PLANNING COMMISSION STAFF REPORT

Meeting Date: May 21, 2024

RE: Application 2021-00000060/DP (Silver Creek Estates); No Address Assigned (APN 019-820-001-000); Applicant/Owner: Neptune Investment LLC – Reza Shera; Agents: FormGrey Studio/SCO Planning

Building 1 and 8 Elevations

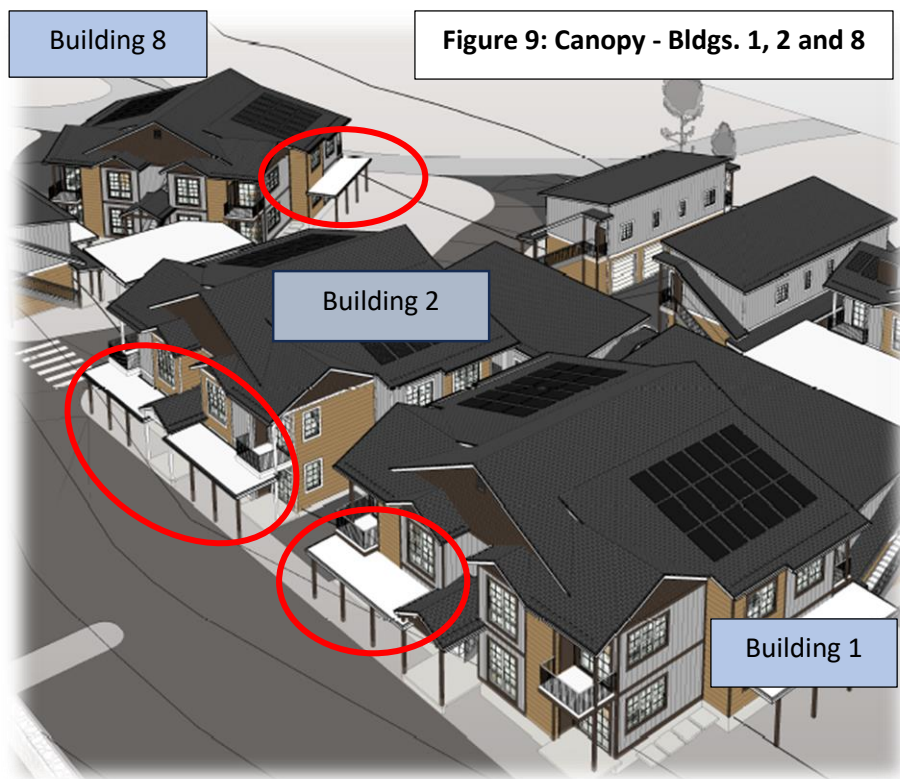
As the proposed roof design sheds snow onto pedestrian walkways and parking areas (COA #23), the developer has chosen to add canopies rather than redesign.

Figure 10: Building 2 Elevations and Floor Plans

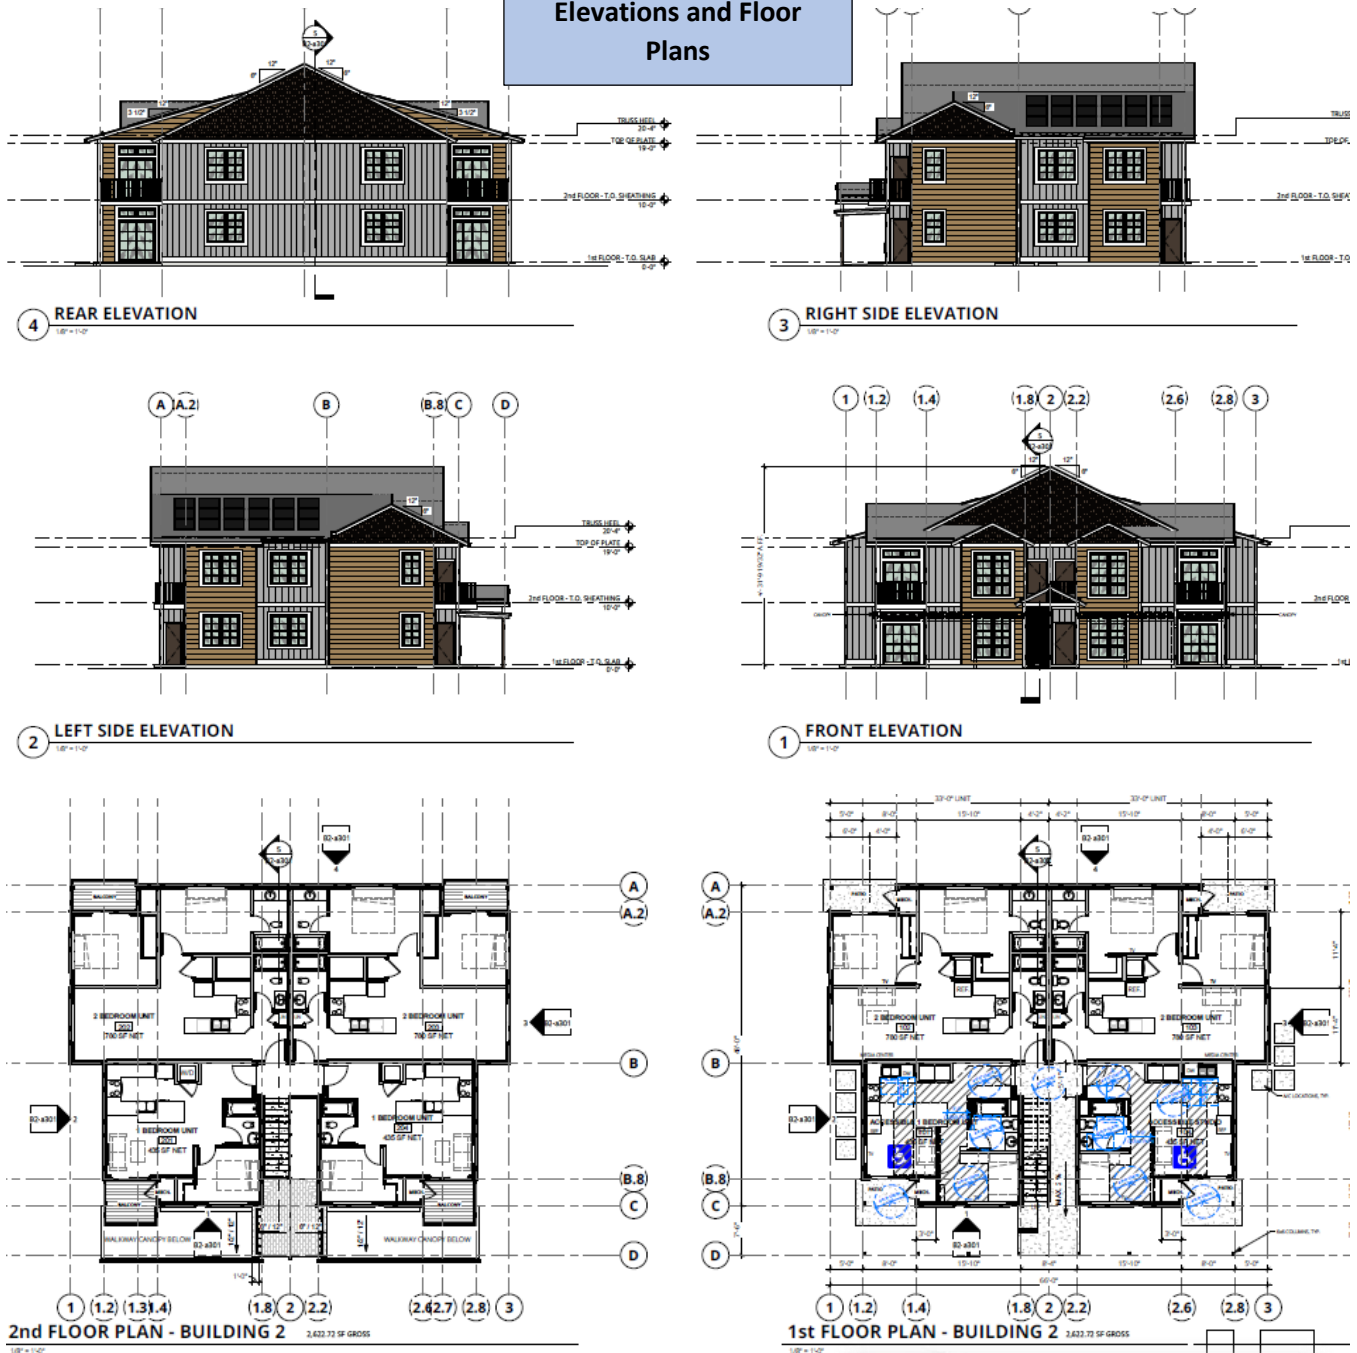
Building 2 is a 5,247-sf two-story building, similar in style to Buildings 1 and 8, but with a different floor plan. The first floor includes two two-bedroom units, one one-bedroom unit and one studio. The one bedroom and studio units are accessible units. The second floor is comprised of two two-bedroom units and two one-bedroom units. Canopies are also shown along the entirety of the front elevation to deflect roof snow shed off the pedestrian path of travel (Figure 9).

Figure 11: Building 5 – Elevations and Floor Plans

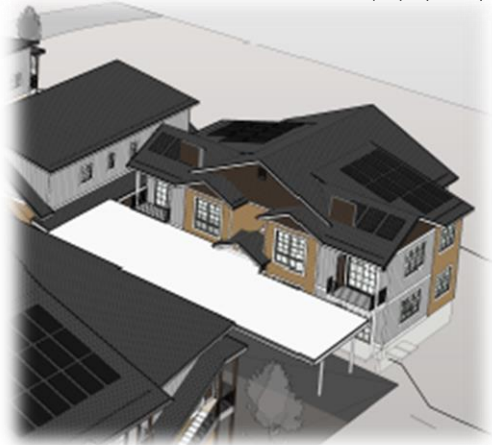
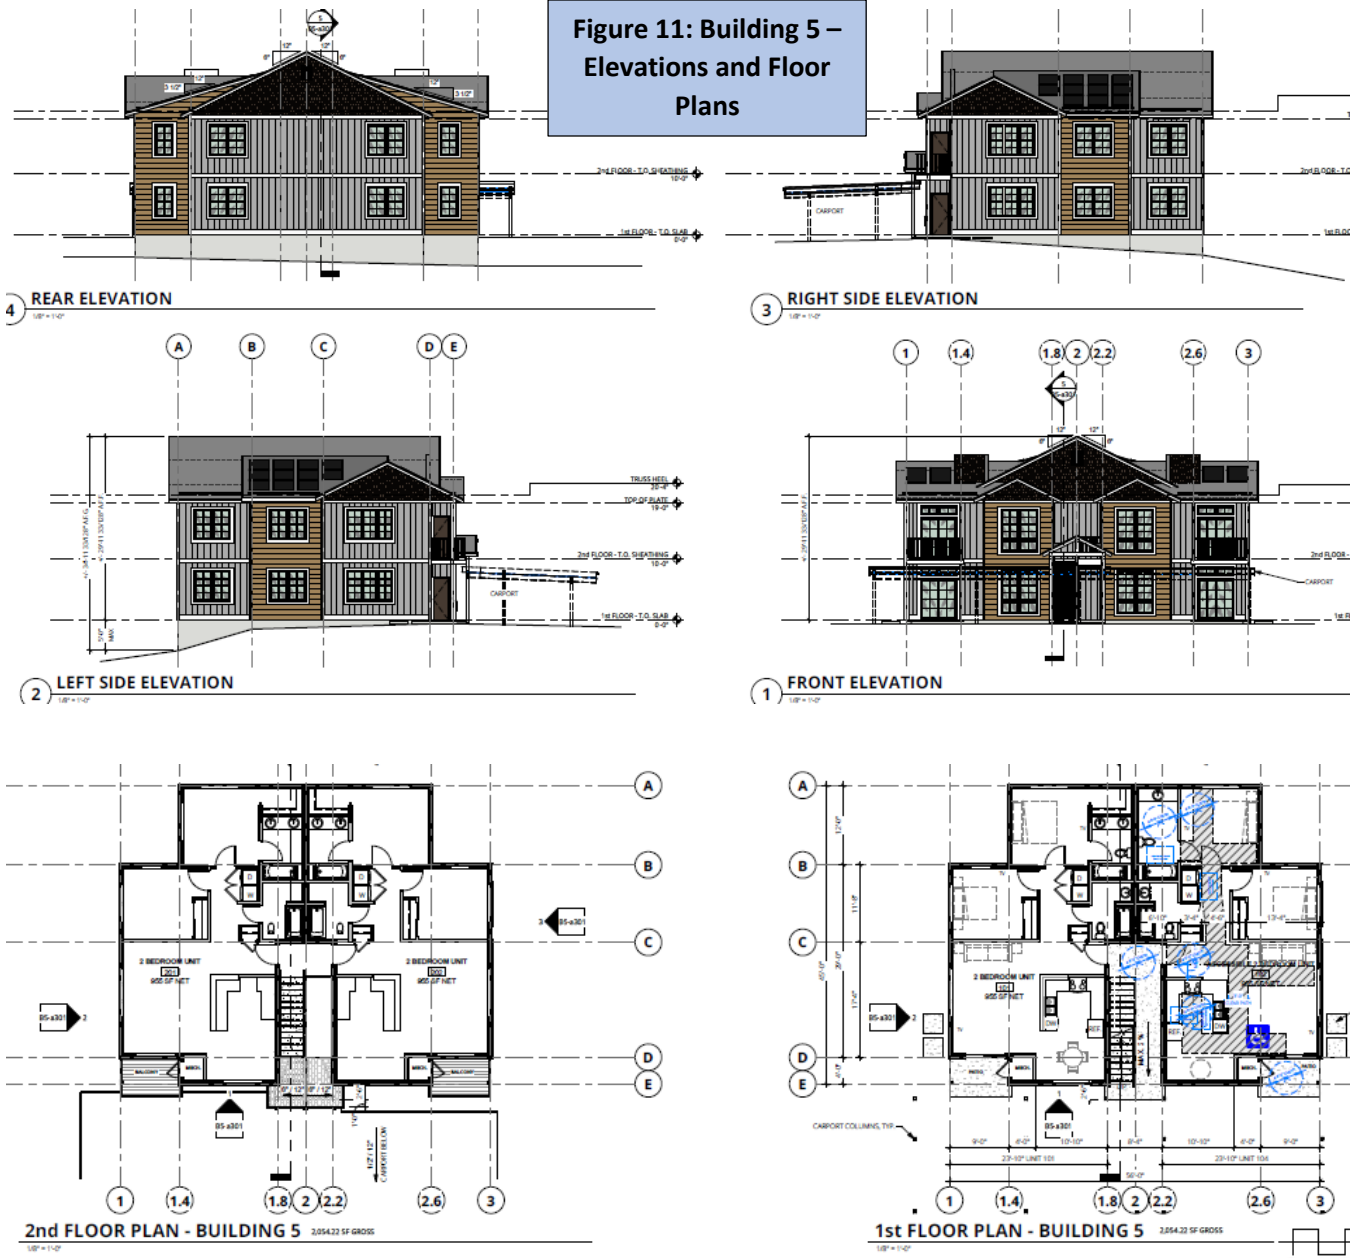
Building 5 is a two-story 4,108 sf structure with four two-bedroom units, two on each floor. An accessible unit is located on the first floor. The roof design sheds snow onto the uncovered parking areas and the developer has designed carport structures in order to prevent snow shedding directly onto vehicles.

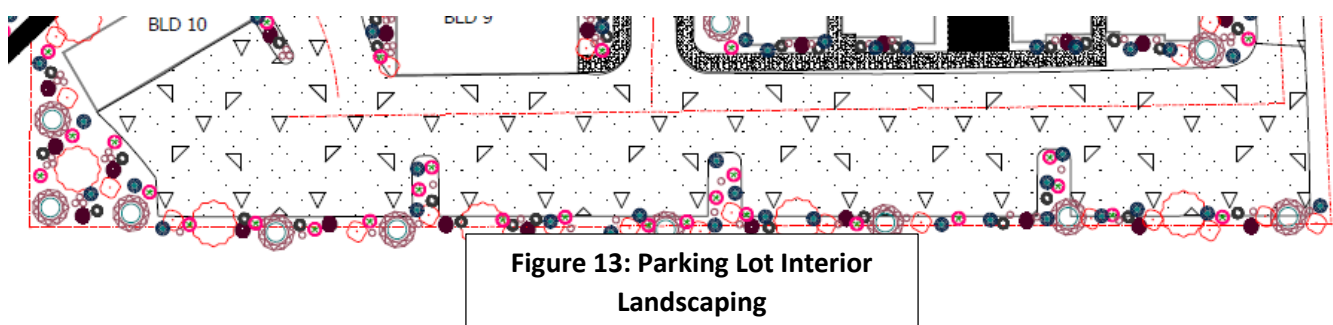
The project is providing parking lot interior landscaping (Figure 13 – example, see full sized plan in Attachment 1), however, not the full amount as described above which is not consistent with the Development Code standards for multifamily development. Condition of Approval #60 will require a final landscaping plan that reflects the approved site plan. The applicant has requested to reduce this landscaping requirement, stating that requiring the project to fully meet the parking lot interior landscaping standard would physically preclude the construction of the project at its permitted density.
